**From:** Brandon Tate <btate@tatefabricating.com>  
**Sent:** Thursday, August 19, 2021 1:24 PM  
**To:** Justin Dolzen  
**Cc:** Ronald Tate  
**Subject:** [EXTERNAL] Re: 74-0087/978595 surface coating  
**Attachments:** 2021-08-19 08.22.17.jpg

**From:** Justin Dolzen <Justin.Dolzen@tn.gov>  
**Sent:** Wednesday, August 18, 2021 12:07 PM  
**To:** Brandon Tate <btate@tatefabricating.com>  
**Subject:** 74-0087/978595 surface coating

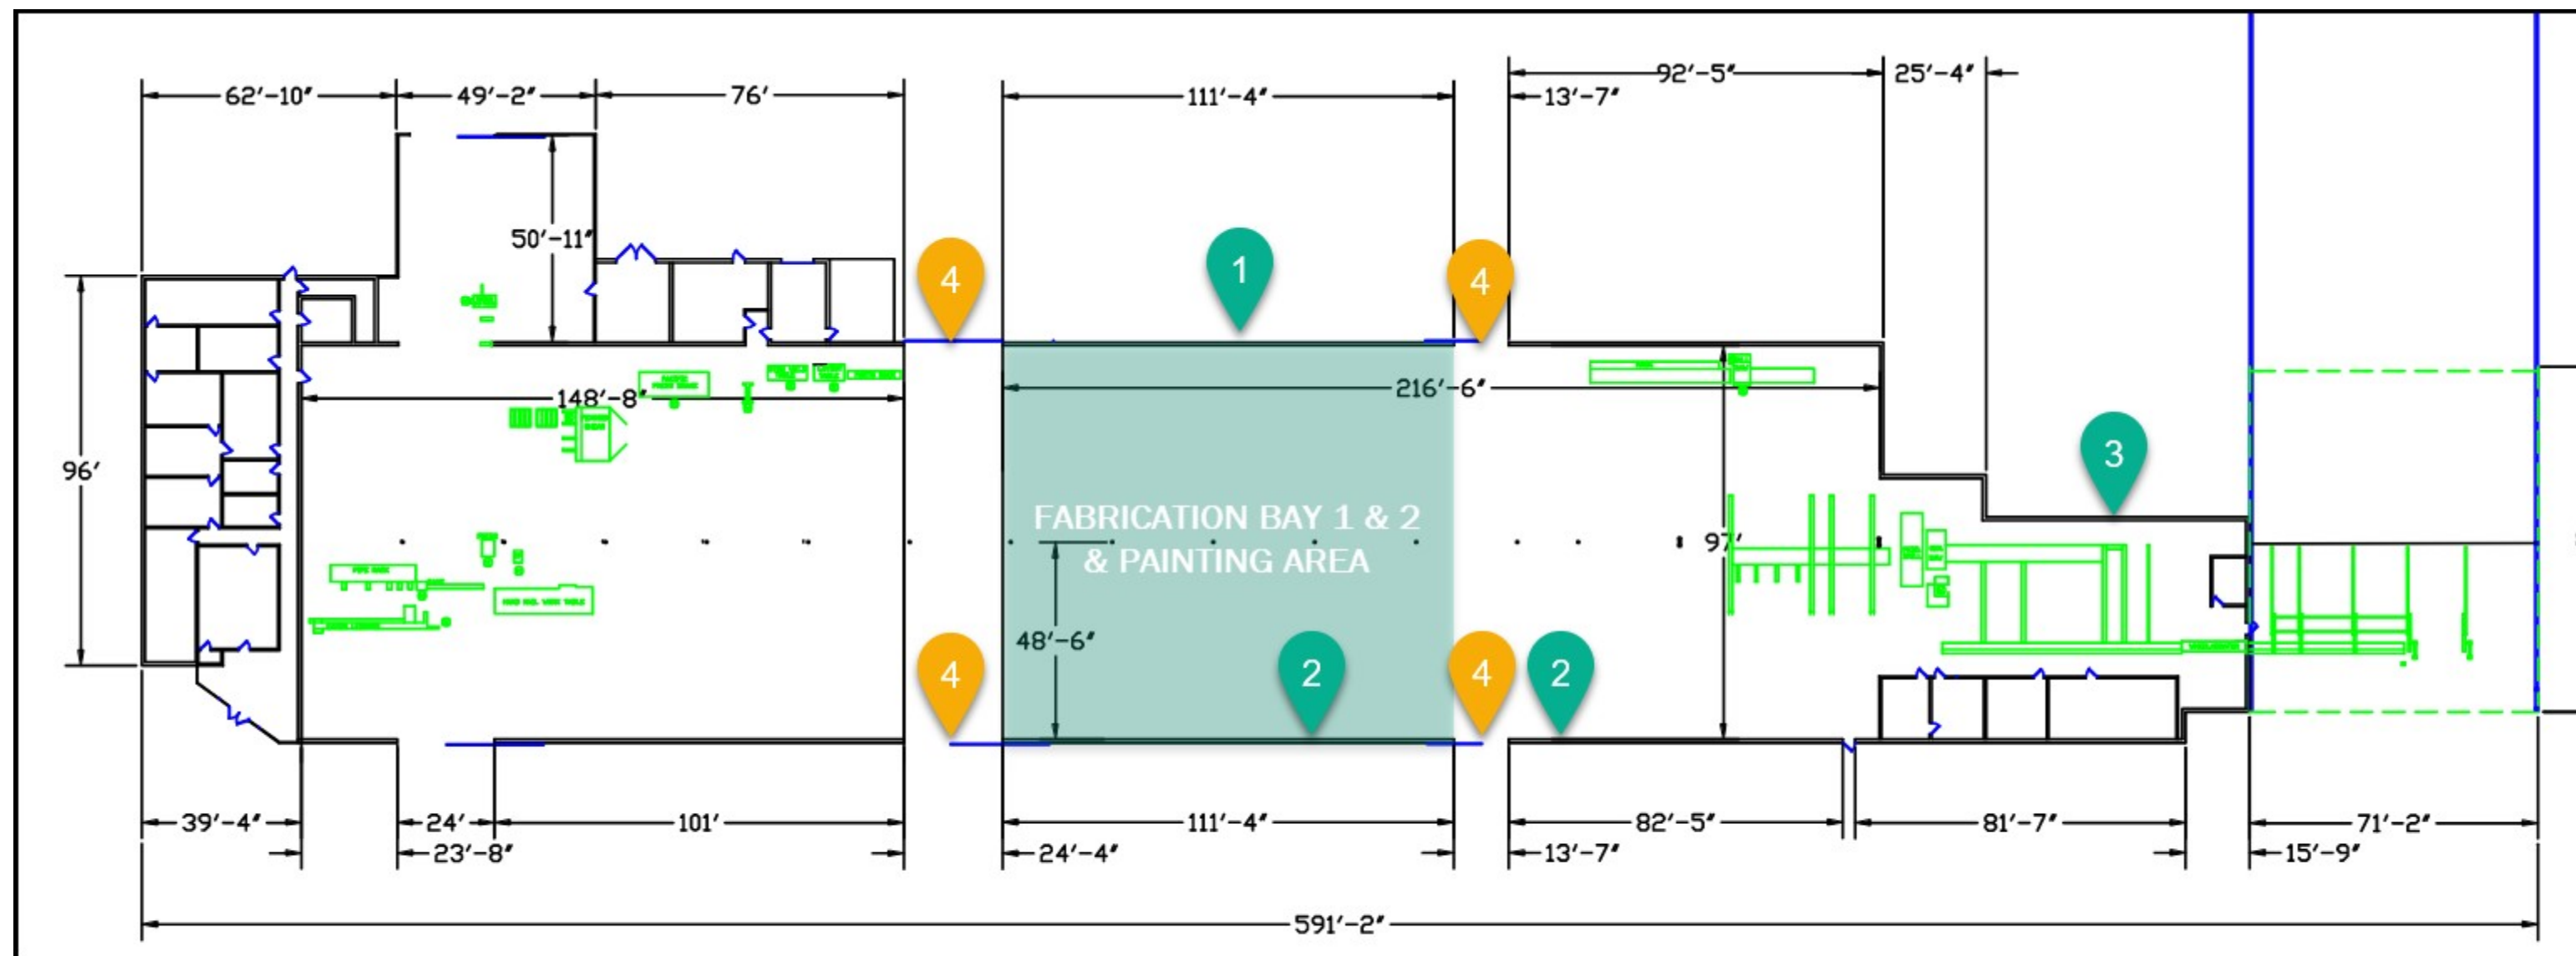
I have a question about the ventilation situation in the building where surface coating takes place. In the application for the surface coating operation it's stated that the airflow volume is unknown because doors are often opened along the sides of the building for air flow. Are there any general exhaust fans for that part of the building for which you would be able to determine air flow?

The shop is 99' wide and at 480' exceeds the length of a football field. The ceiling height ranges from 19' at the wall to 22' at the centerline. The painting occurs in Fabrication Bays 1 & 2 in the area depicted on the schematic below. There are numerous fans throughout the shop for circulation and in-wall ventilation/exhaust fans at the top of the wall as noted on the schematic. The bay doors are full height. Bay door locations are indicated on the schematic.
